MEMORANDUM

To: Development Review Board
From: Mary O'Neil, AICP, Principal Planner
Date: July 20, 2021
RE: ZP21-479; 1-7 Church Street

Location: 1-7 Church Street (Masonic Temple)

Request: Alternative/Alternate Compliance for blade sign.

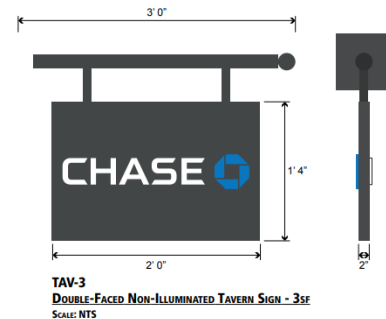
c) The relief, if granted, is the minimum variation necessary from the applicable standard to achieve the desired result;

As there is no solid surface on which to install the proposed blade sign within the allowed 48”, centering it on the pier is an understandable deviation from the applicable standard.

The application specifically requests relief from the standard that limits blade sign installation to within 48" from a principal entrance. The installation distance proposed is 76" from the entrance, to secure a firm structural component on which to install the sign, centering it on an architectural pier. *Alternative Compliance* under Article 7 requires DRB review, however the 20% deviation from the standard falls within the glazing area and therefore falls short of the allowable *Alternative Compliance* of Article 7.

Affirmative finding, if DRB concurs with discretionary allowance for Alternate Compliance under Article 14.
